CITY OF SOUTH ST. PAUL MEETING AGENDA

A. Camber Hill Townhomes Renovation Project Development Application

PLANNING COMMISSION AGENDA REPORT

Re: Camber Hill Townhome Renovation Project
Site Plan Review

ELECTRICAL SITE LIGHTING PHOTOMETRICS

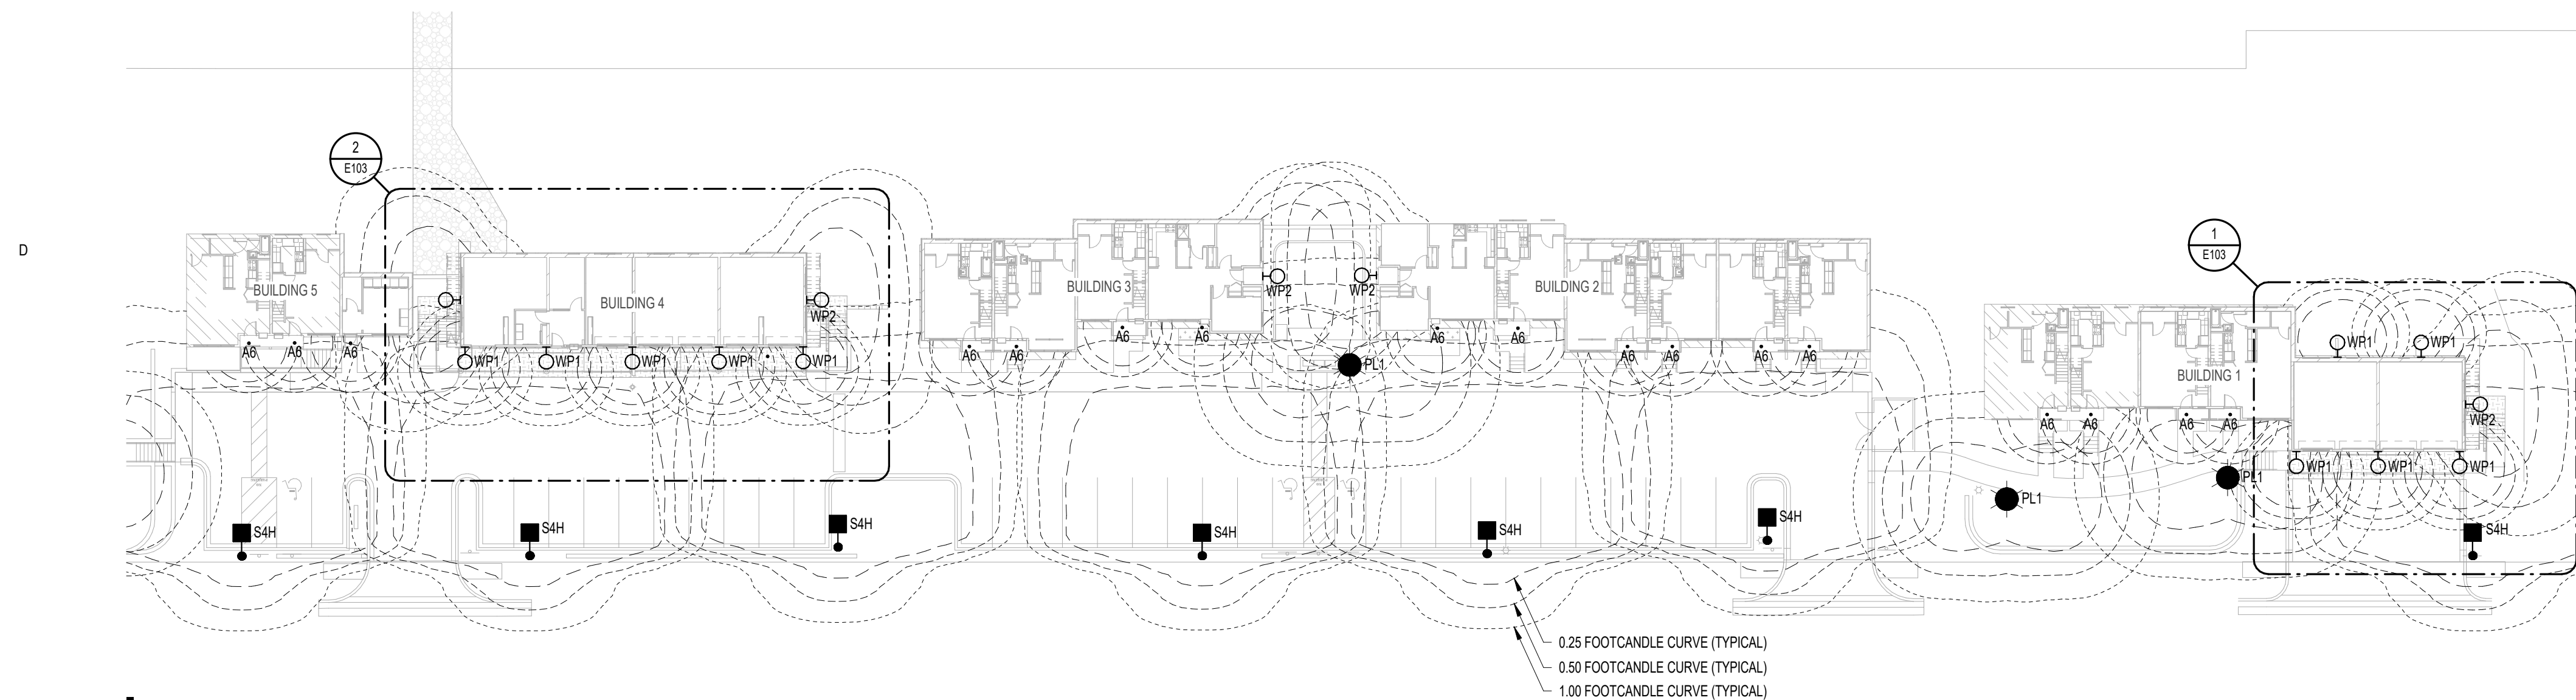
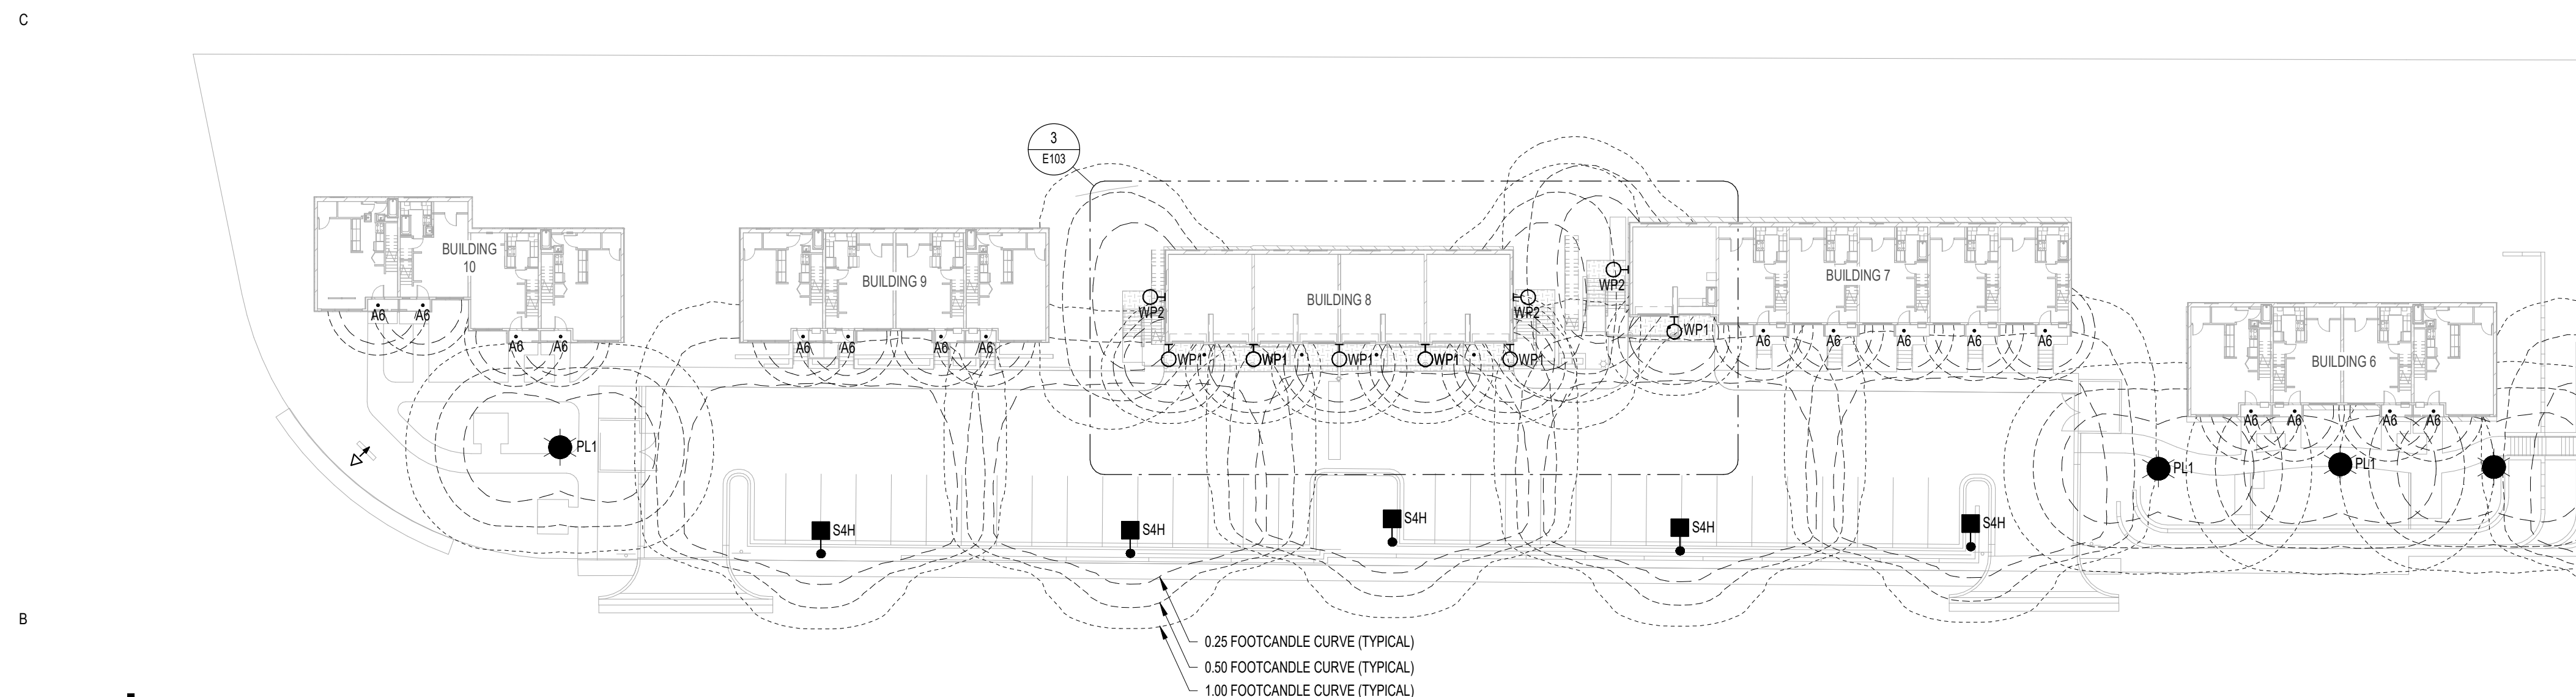
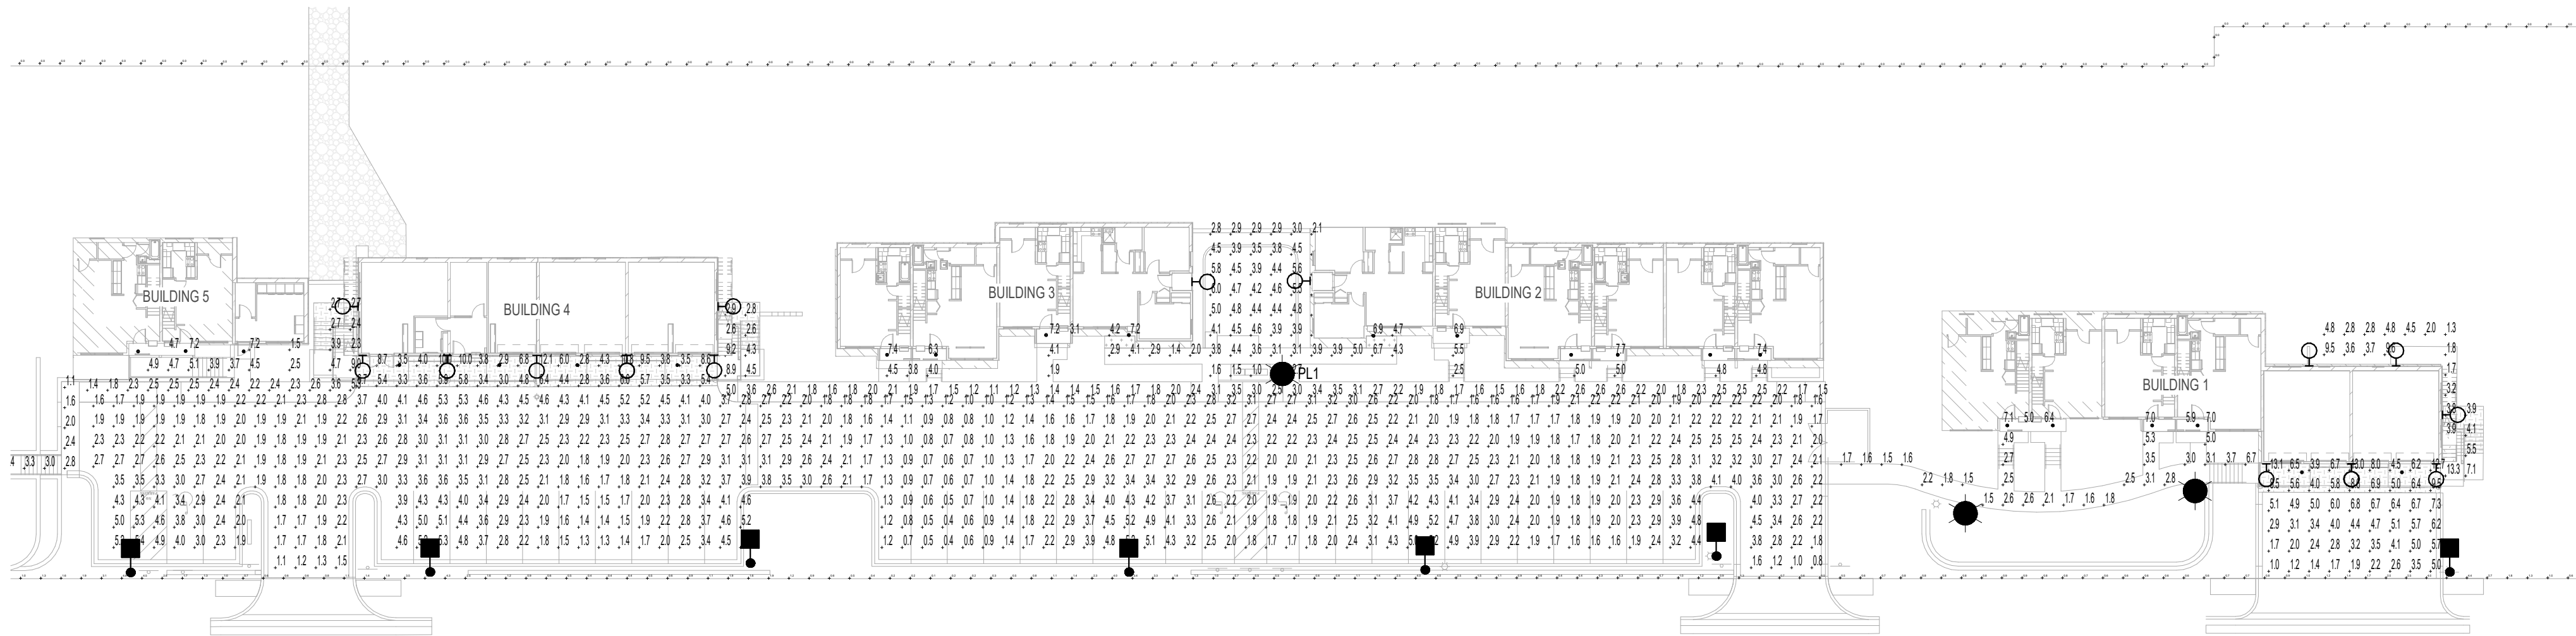
9. **Lighting.** All lighting shall be compliant with City Code Section 18-245 and a revised photometric plan shall be submitted that demonstrates that no more than 1 footcandle of light shall be spilled onto the centerline of the road. Light sources shall be hooded or controlled so as not to light adjacent property. The Applicant is granted a variance from these provisions for the property line that exists between Building #5 and Building #6. The Applicant may treat their entire development as one property for the purposes of administering the lighting and glare ordinance.
